<b>Well Name:</b> SAKER 6-7 FEDERAL COM	<b>Well Location:</b> T24S / R35E / SEC 6 / LOT 2 / 32.251866 / -103.403597	<b>County or Parish/State:</b> LEA / NM
<b>Well Number:</b> 25H	<b>Type of Well:</b> OIL WELL	<b>Allottee or Tribe Name:</b>
<b>Lease Number:</b> NMNM014164	<b>Unit or CA Name:</b>	<b>Unit or CA Number:</b>
<b>US Well Number:</b> 3002550510	<b>Operator:</b> OXY USA INCORPORATED

**Type of Action:** APD Change

**Procedure Description:** OXY USA Inc., respectfully requests to amend the subject AAPD to revise the SHL, BHL, Well Pad, TVD and Drill Plan. Old SHL: 710' FNL 1688' FEL New SHL: 200 FNL 1760 FWL Old BHL: 20' FSL 2306' FEL New BHL: 20 FSL 2260 FEL Old Well Pad: Falcon Ridge 0606 New Well Pad: Falcon Ridge 0602 Old TVD: 11222' New TVD: 10375' \*THERE IS NO ADDITIONAL SURFACE DISTURBANCE RELATED TO THIS SUNDRY" Attached is the updated C102, drill plan, directional and APD Change Worksheet.

Property Name SAKER 6_7 FED COM	Well Number 25H	Drawn By R.J. 12-20-19	Revised By REV: 3 L.T.T. 03-31-25 (WELLBORE CHANGES)
------------------------------------	--------------------	---------------------------	---

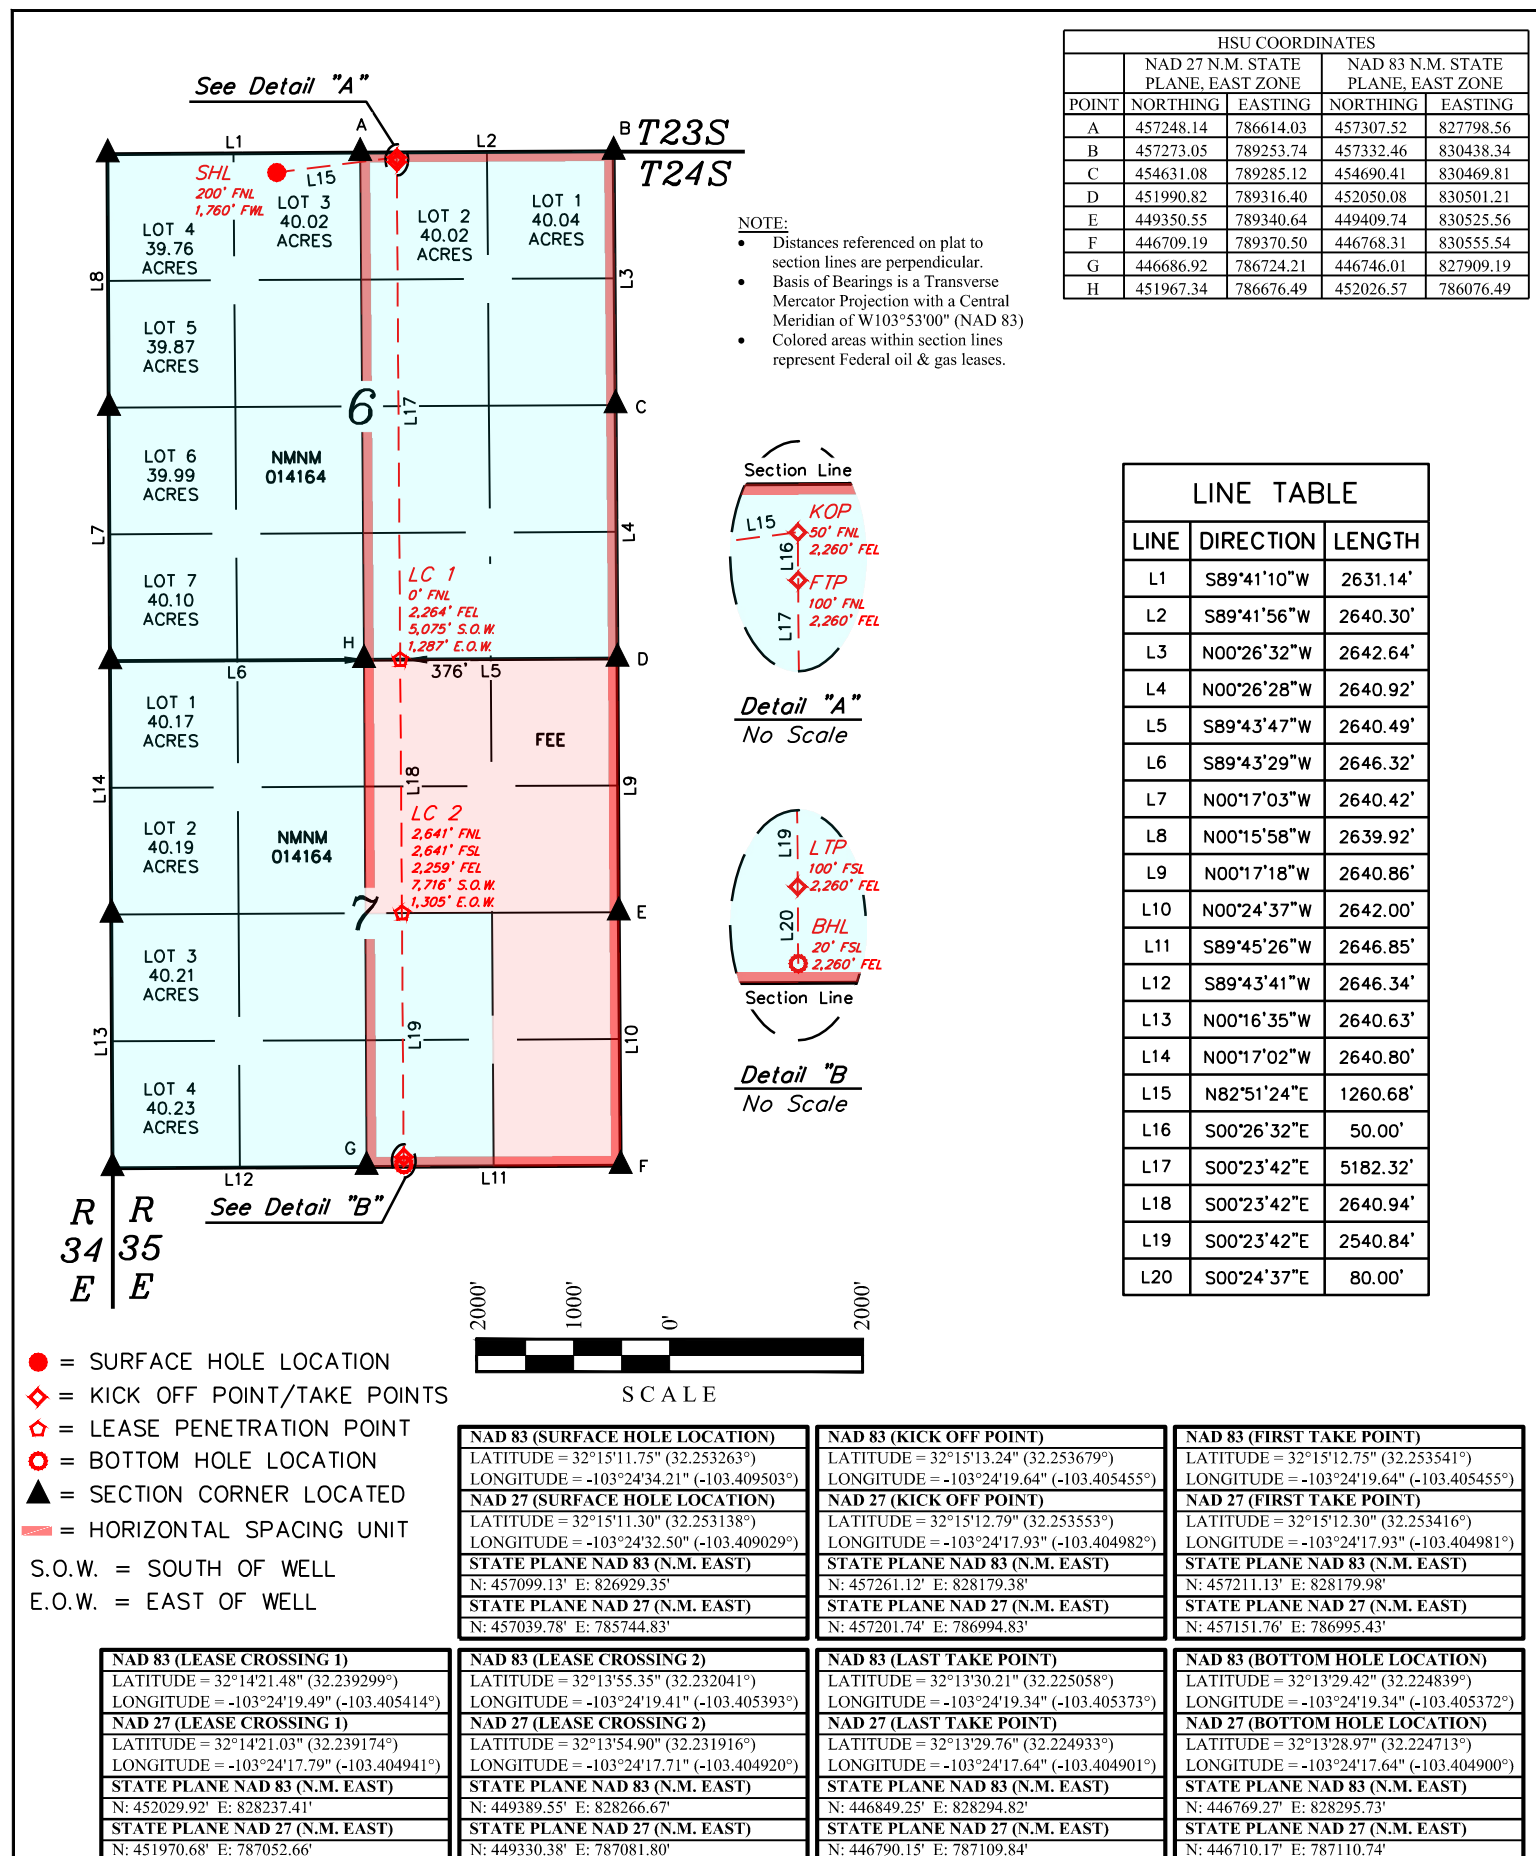
OXY USA Inc., respectfully requests to amend the subject AAPD to revise the SHL, BHL, Well Pad, TVD and Drill Plan.

Old SHL: 710' FNL 1688' FEL

New SHL: 200 FNL 1760 FWL

Old BHL: 20' FSL 2306' FEL

New BHL: 20 FSL 2260 FEL

Old Well Pad: Falcon Ridge 0606

New Well Pad: Falcon Ridge 0602

Old TVD: 11222'

New TVD: 10375'
